Consultation note regarding the 3rd consultation on the Model

DBA started the 3rd consultation on the Model on the 1st of September. By the end of the consultation period on the 6th of October DBA had received consultation responses from Dansk Energi (DE), DI Digital, Fastspeed, Norlys, TDC, Telenor, and Telia.

This document includes a verbatim copy of the comments provided by the stakeholders, along with responses from DBA to each comment separately. The accepted feedback to the Model has been implemented into it.

Figure 1: Coax network access costs to be paid twice as costs for 3rd party network is incorrectly included in LRAIC round 3 model:

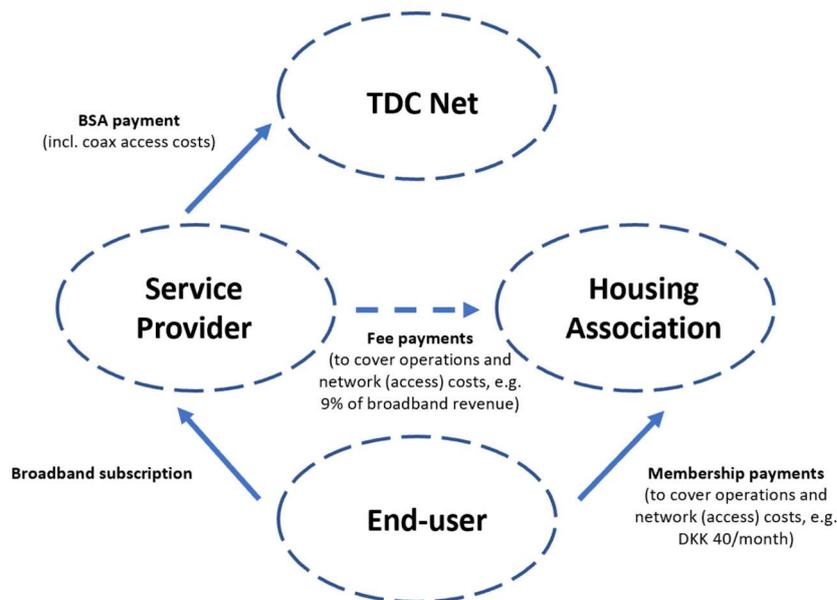
When BSA products are being offered on third party infrastructure, also known as privately owned networks, it is important to note that the access cost should not be included in the model. The reason for this being that the cost of access infrastructure on these networks are paid by the end-users via a membership fee (or

via housing rent) or sometimes even the service providers invoiced directly by the network association and not TDC (or Norlys) as BSA provider (see figure 1 below). The model should therefore distinguish between privately owned networks and infrastructure owned by e.g. TDC (or Norlys) and model costs accordingly.

Please, see the response presented to comment 4 from Telenor in Question 18 above.

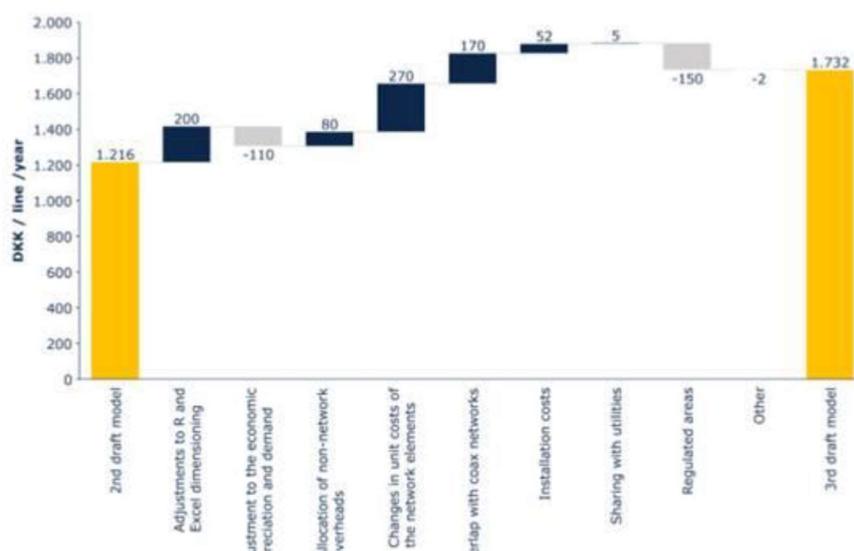
We do not agree with this conclusion, it is mathematically incorrect. An update of the footprint to include more 'costly' addresses would increase the costs in the entire modelling period (from year 2005 to 2038) due to the applied Economic Depreciation method. However, the fibre provider can only charge the additional cost in the years to come. For example, a decision of further investment in an expansion of the footprint – say – from year 2023 will model-wise distribute the additional costs from that investment over all model years 2005 – 2038 but the fibre providers can only charge their SP customers the higher costs from 2023 – 2038. As such, the model will only ensure partial cost recovery and thus make investments outside of the footprint modelled initially unprofitable.

This issue illustrates a fundamental and general challenge to the premise of modelling the costs of network footprints that are under construction and the need to think carefully about retaining the incentive for fibre providers to keep investing in network expansion. We believe this shows that the DBA must be very careful in regulating wholesale prices based on this model and at the very least assume conservative estimates of costs.

DBA acknowledges that due to the implementation of the economic depreciation methodology, changing the forecasts in the future will also have an effect on past costs. This is why DBA decided to promote operators' involvement in the provision of accurate forecasts from the very beginning of this project. The availability of operators' future deployment plans allows the model to perform all

calculations consistently with their own projections and, thus, the costs to be recovered over the years are consistent with the network footprint of the operator over the same years.

Figure 1: Characterisation of TDCs central offices into geotypes [Source: Exhibit 6.1 of R model manual 3rd draft - Axon Consulting.]

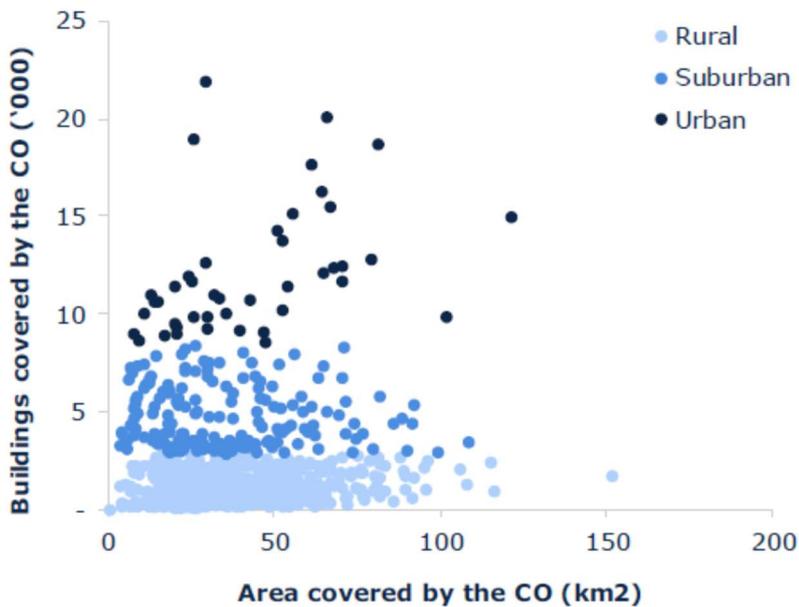
Based on Figure 1, it is clear that ‘Area covered by CO’ is effectively ignored, hence ignoring the density of a given CO. One will obtain almost identical results using ‘Buildings covered by the CO’ only to determine geotype using ‘K-means’.

By examining the Geotype classification contained in the dataframe T_Buildings, less than 2% of all COs are categorized as Urban and less than 7% are categorized as Suburban (see Table 1). In Figure 2, a replication of Exhibit 6.1 from R Model 3rd draft version is shown. To validate the replication, we have cross-referenced the geotypes found in the input file CO_Cover_Order.xlsx. We conclude that the number of Urban and Suburban COs are significantly lower than what is reported by Axon in Exhibit 6.1.
